Response to Information Request – Development Application at 424 Bowen Terrace New Farm Qld 4005 (Council Ref.: A007082)

In accordance with Section 13.2 of the Development Assessment Rules and on behalf of *Fortis Pty Ltd* ('the **Applicant**'), please find below the Applicant's responses to the information request requested by Council on 8 September 2026 for the abovementioned Change (Other) application.

Figure 1 - Excerpt of approved plans (identifying material palette and legend)

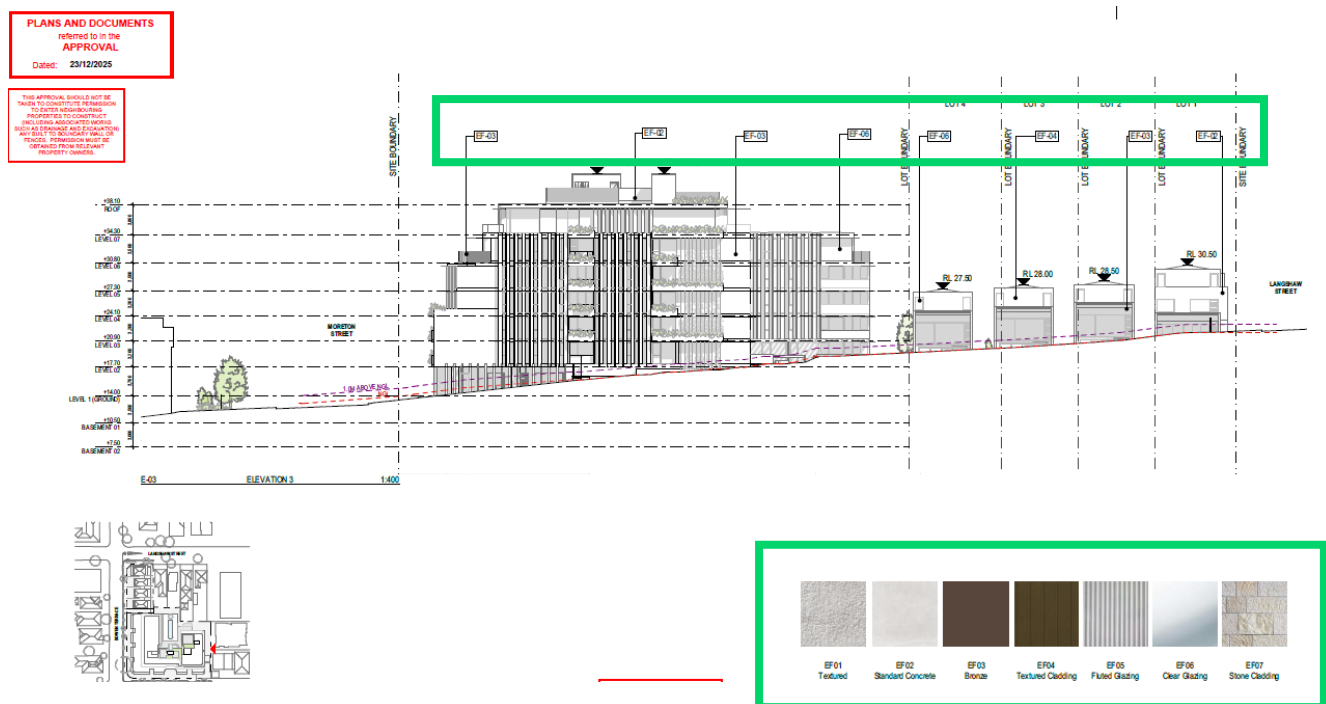
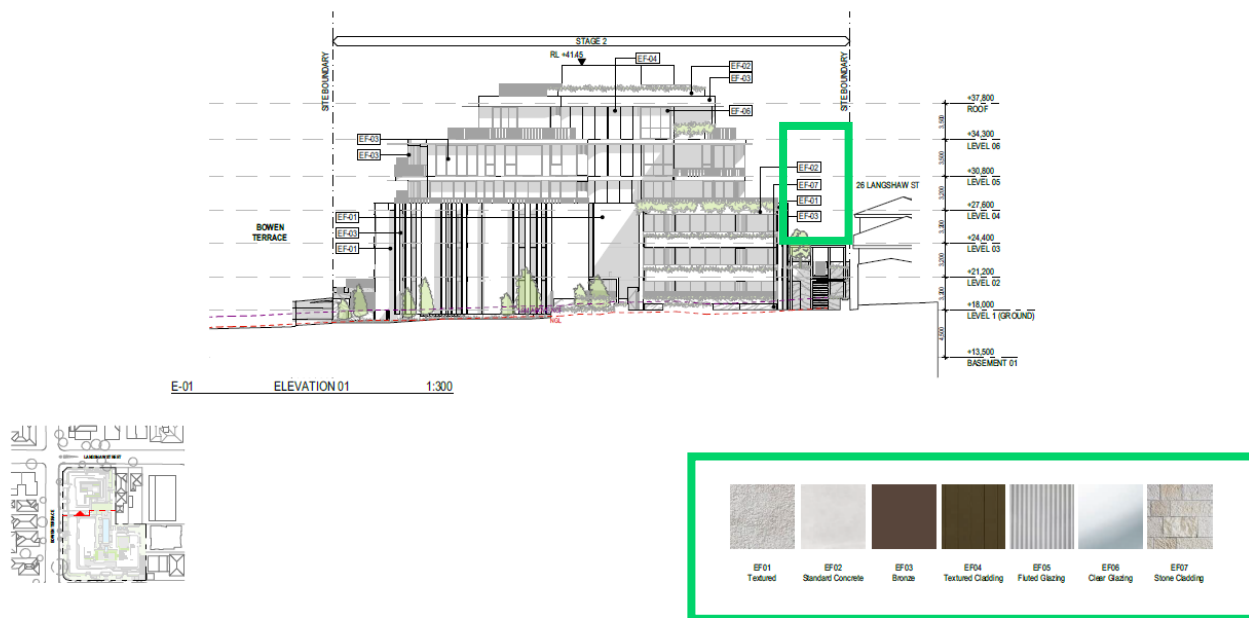
2. *It is acknowledged the elevation plans are labelled with the materials to be used, however the illustrations do not clearly show the appearance of the elevations is sufficiently varied in treatment,*

materials, colours, textures and finishes in compliance with AO9.3 and AO9.4 of the Multiple dwelling code.

- a. Provide amended plans showing the variation clearer on the elevations required under AO9.3-AO9.4/PO9 of the Multiple dwelling code.

In response to Item 2, the Applicant wishes to advise that the architectural package prepared by DKO and included as Appendix D at the time of lodgement includes a suite of elevation drawings which include the intended material selections. The material palette has been included on each elevation drawing accompanied by a legend which details the application of each material choice across the buildings.

We note that the presentation of the material palette in the architectural package provided at lodgement is consistent with that which was approved in the originating application. As such, we seek Council's discretion in this regard and request that Council proceed with assessing the development with the materials provided. For context, comparison images between the approved architectural package with the proposed architectural package are provided below to demonstrate the consistency between the approved architectural package and those proposed as part of this Change (Other). Please refer to **Figure 1** and **Figure 2** below.
